# SIDE STAND SPRING REPLACEMENT AND ENGINE BREATHING LINE CHECK

**2025 SMC R**

## RESTRICTIONS: AFFECTED MODELS ARE LINKED BY VIN IN DEALER.NET

Fig.. 1 – engine breathing pipe

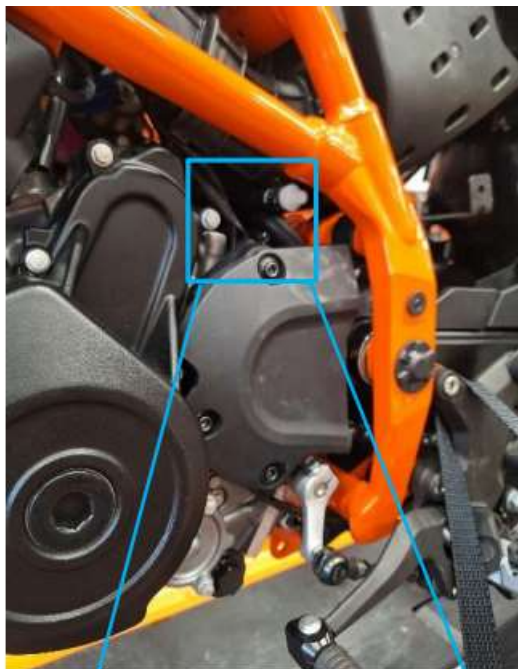
Check the routing of the engine breathing line (see Fig. 1, 2 and 3):

Make sure that the line is not kinked and/or pinched between the ground cable and the air filter box. Visual inspection, correction if necessary. (see Fig. 1 and Fig. 2) If a correction is necessary, a separate warranty claim can be submitted.

**Fig. 4 – Forged side stand**

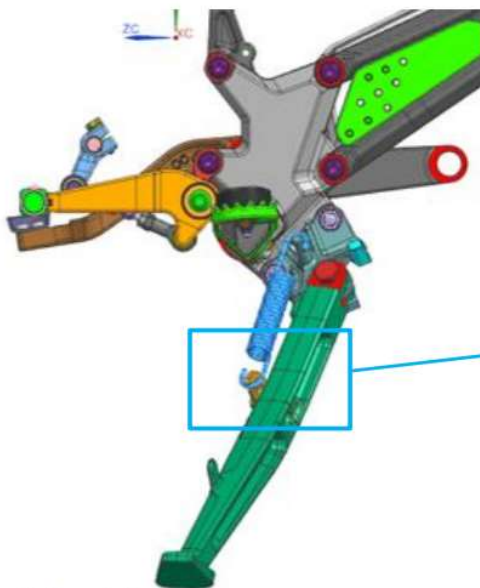
1. Take off the side stand spring and spring holder.

Fit the new spring retaining bracket (A60103028200) with SK collar screw M8x14 – (J900000801402) and tighten to the specified torque, see Table 1.

**Attention:** Note the installation position (see Fig. 4).

**Fig. 5 – Installation position spring bracket side stand**

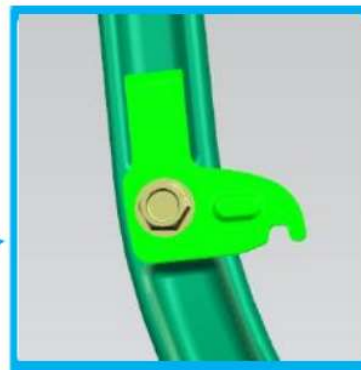
2. Attach the new side stand spring (A60103224000).

**Attention:** Note the installation position, long spring end direction upwards and open end direction to the rear (see Fig. 5).
